PG&E Letter DCL-13-046

Response to NRC Request for Additional Information Regarding Request for  
Approval of an Alternative to the American Society of Mechanical Engineers (ASME)  
Boiler and Pressure Vessel Code Section XI Pressure Test Requirements for  
Class 1 Reactor Vessel Flange Leakoff Lines

PG&E Response to NRC Request for Additional Information Regarding Request for Approval of an Alternative to the American Society of Mechanical Engineers (ASME) Boiler and Pressure Vessel Code Section XI Pressure Test Requirements for Class 1 Reactor Vessel Flange Leakoff Lines

**Piping and Instrumentation Diagram for Reactor Coolant System for Unit 1**

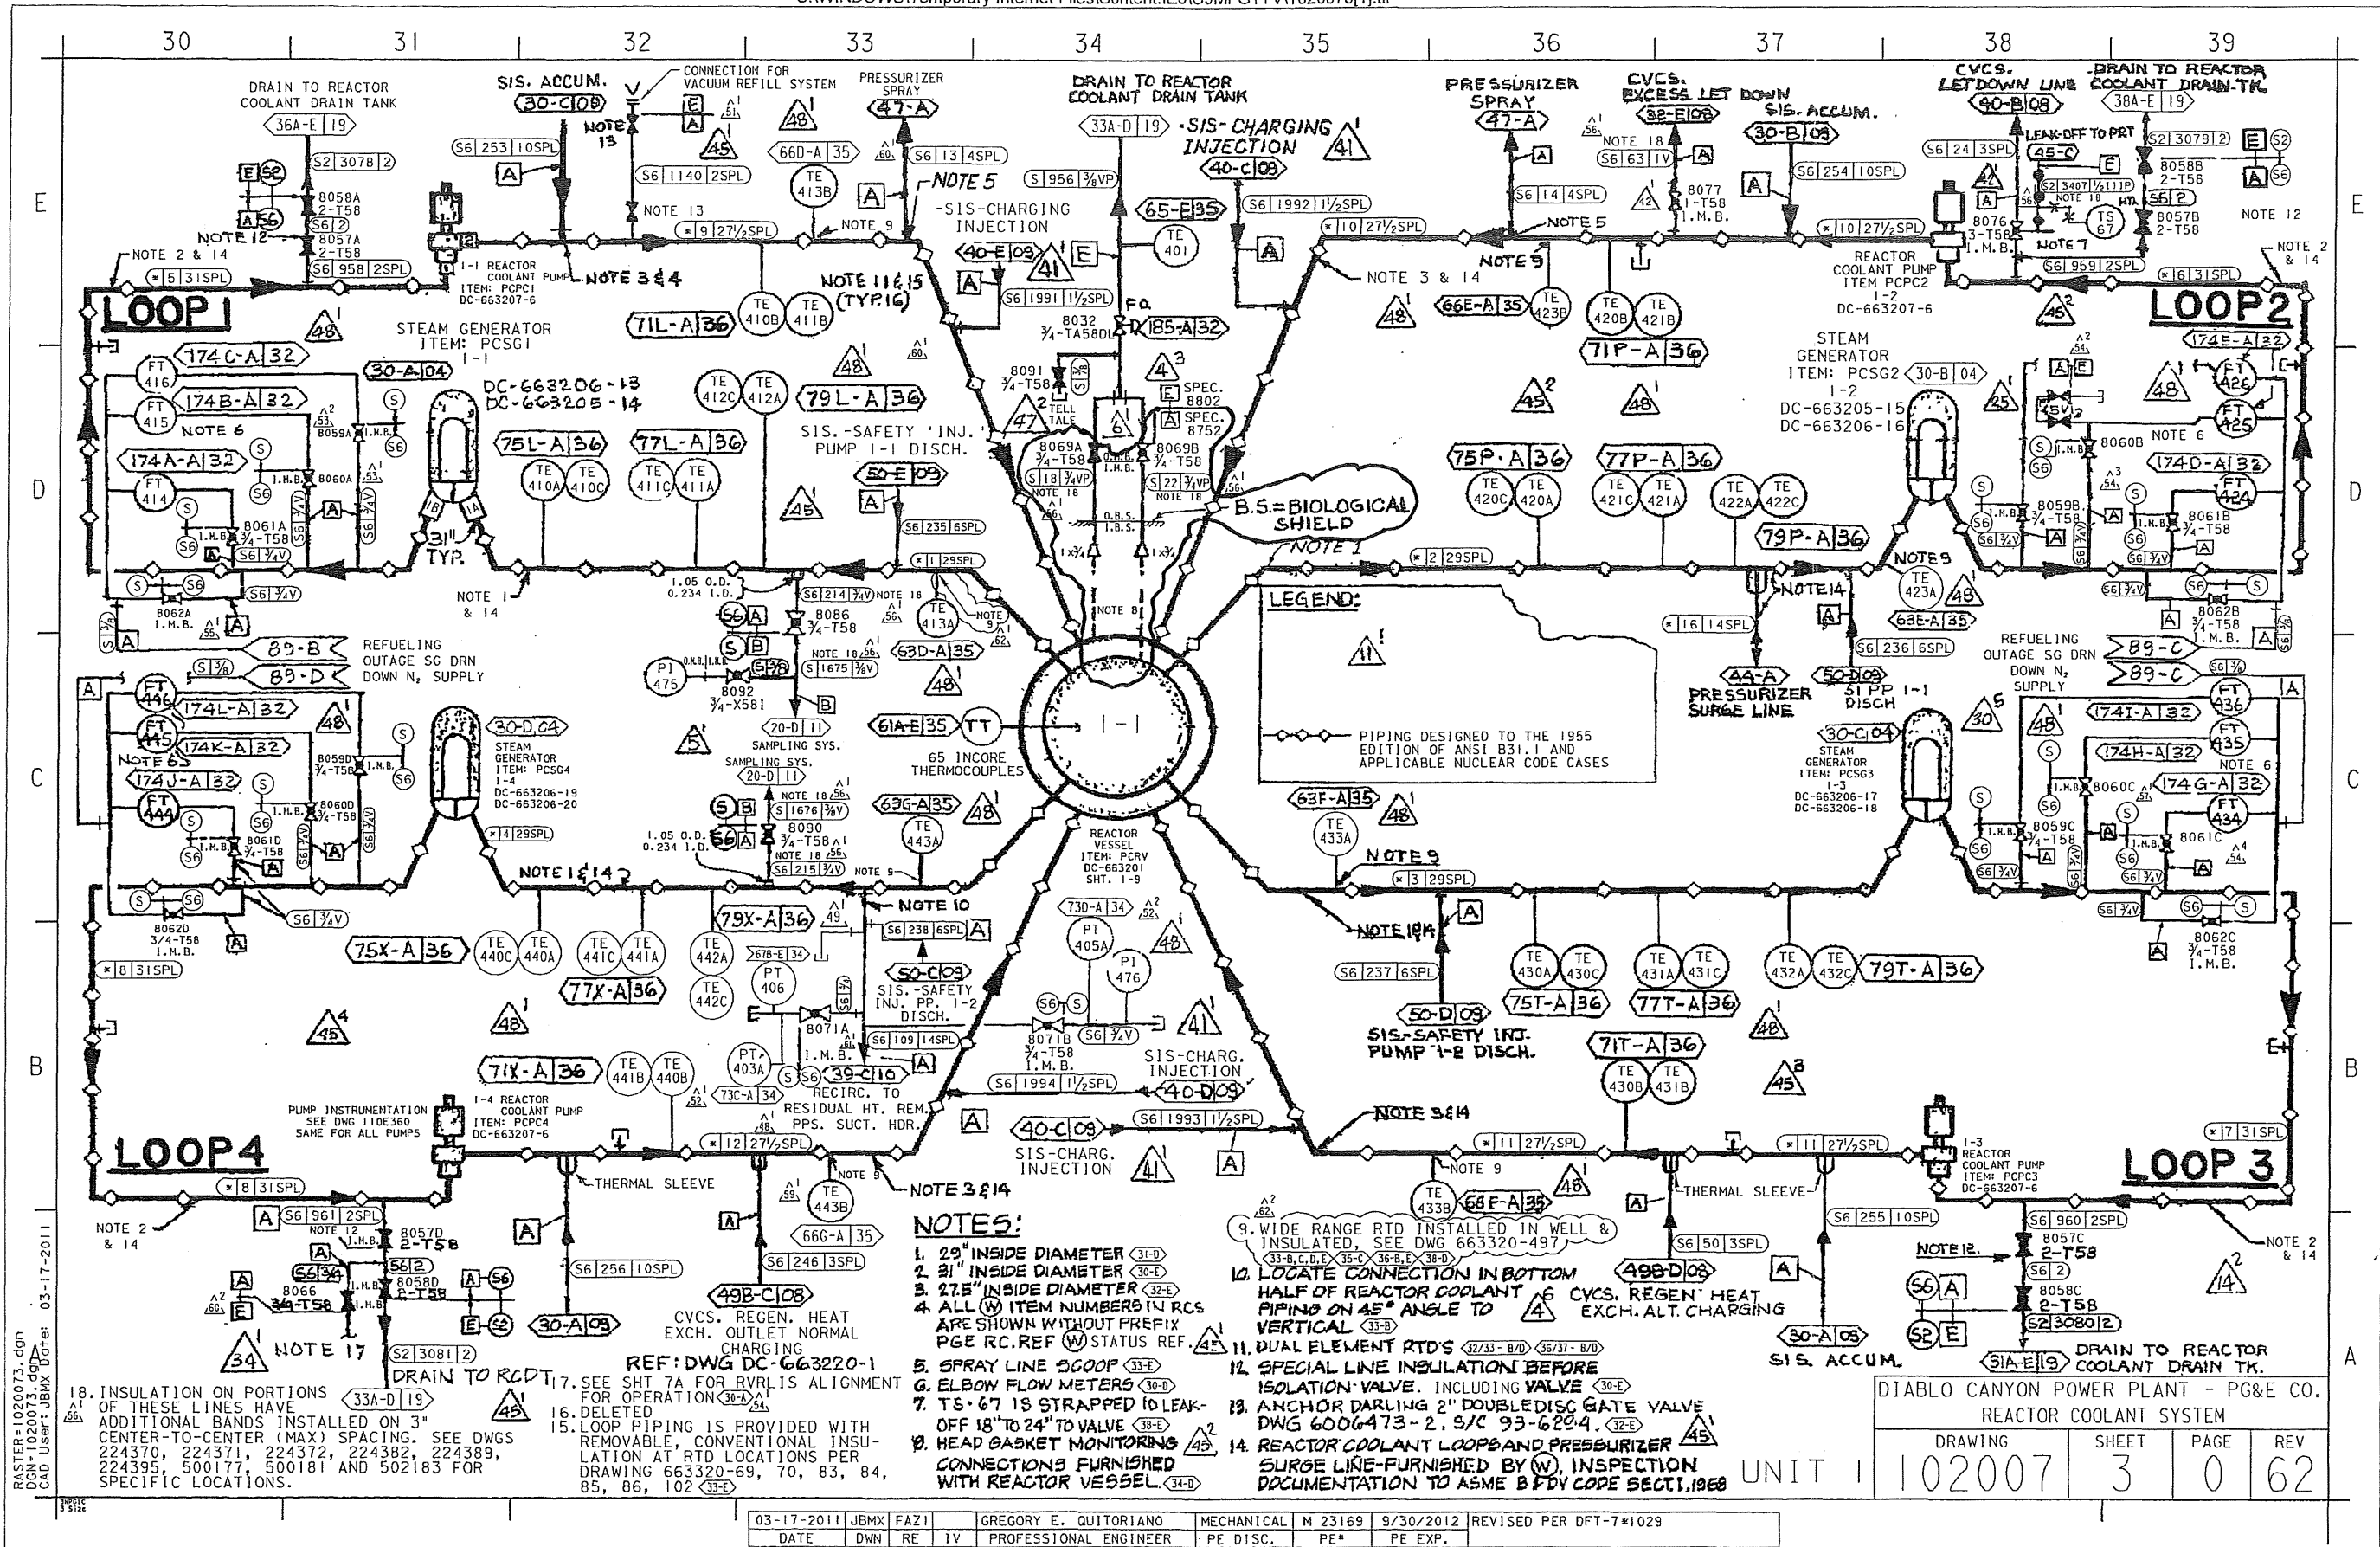
- (1) Submit a piping and instrumentation diagram (P&ID) for the entire reactor vessel head flange leakoff system.*
- (2) Identify on the P&ID the pipe segments that are required to be examined in accordance with the ASME Code, Section XI, Table IWB-2500-1, Examination Category B-P and Item Number B15.10.*
- (3) Identify on the P&ID the pipe segments that are accessible and inaccessible for inspection.*

- (1) Describe the system alignment and configuration of the leakoff lines during normal operation (e.g., valve positions, alarm setpoints, etc.). Pictorial representations via the above requested P&IDs may be helpful.*
- (2) When leakage is detected via high temperature alarm initiation, discuss the procedures in response to that leakage in the O-ring leakoff line (e.g., describe the actions that would be taken after the alarm is initiated).*
- (3) If the leakoff line itself was degraded (leaking) and diverting leakoff, discuss how it would be determined if the leakoff line itself was leaking, once the above alarm actuated.*

- (1) A P&ID for the reactor vessel head flange leakoff system for Unit 1 is presented in Attachment 1 of the enclosure. A P&ID for Unit 2 is presented in Attachment 2 of the enclosure. The leakoff lines are shown at coordinates 34-D. The portions subject to examination extend from the reactor vessel to and including valves RCS-8069A and B.

- (IBS) refers to the area inside of (or enclosed by) the BS.
  - (OBS) refers to the area outside of the BS.
- (2) The pipe segments that are required to be examined in accordance with the ASME Code Section XI, Table IWB-2500-1, Examination Category B-P and Item Number B15.10 are identified on the attached P&IDs and extend from the connection below the vessel flange penetrations through 1 inch by  $\frac{3}{4}$  inch reducers. The pipe segments continue down and across the biological shield annulus and through the BS, then across and down around the reactor coolant loop area, down and through the MB, terminating at valves RCS-8069A and B. On the P&ID, these portions commence at the reactor vessel and end at valves RCS-8069A and B.

- (3) **The pipe segments that are accessible for examination:** The pipe segments accessible for examination with the refueling cavity filled are those portions outside the BS, i.e., across and down around the reactor coolant loop area, down and through the MB to valves RCS-8069A and B. This portion constitutes the majority of the piping (approximately 90 percent) and is uninsulated except for the portions immediately adjacent to the MB which includes valves RCS-8069A and B. On the P&ID, this portion extends from outside the BS through the MB to valves RCS-8069A and B.

**The pipe segments that are inaccessible for examination when the refueling cavity is filled:** The portion that is inaccessible when pressurized (i.e., with the refueling cavity filled) extends from the connections at and through the vessel flange down and across the biological shield annulus and through the BS penetration. This portion is also uninsulated. On the P&ID, this is shown extending from the reactor vessel to inside the BS.

**The pipe segments that are accessible for examination when the refueling cavity is empty:** The pipe inside the BS annulus, including the lower portion of the downcomers from the vessel flange, the crossing of the annulus and the pipe inside the penetration sleeve is visible from inside the biological shield annulus when the refueling cavity is empty (i.e., the pipe is depressurized) and the access manways are opened.

**The pipe segments that are inaccessible for examination at any time:** The vertical portion extending from the vessel flange connections down to the open biological shield annulus (approximate length of each line is about 5 1/2 feet) passes through the vessel flange and insulation. Then it is tightly fitted between the vessel insulation and the concrete and is not directly accessible at any time.

- (1) The inboard leakoff line (S-22-3/4) is aligned with valve RCS-8069B normally open. Alignment is through valve RCS-8032 past TE-401 to the reactor coolant drain tank (RCDT).

The outboard leakoff line (S-18-3/4) is isolated with valve RCS-8069A normally closed.

TE-401 provides an alarm in the control room when the line temperature exceeds 120°F.
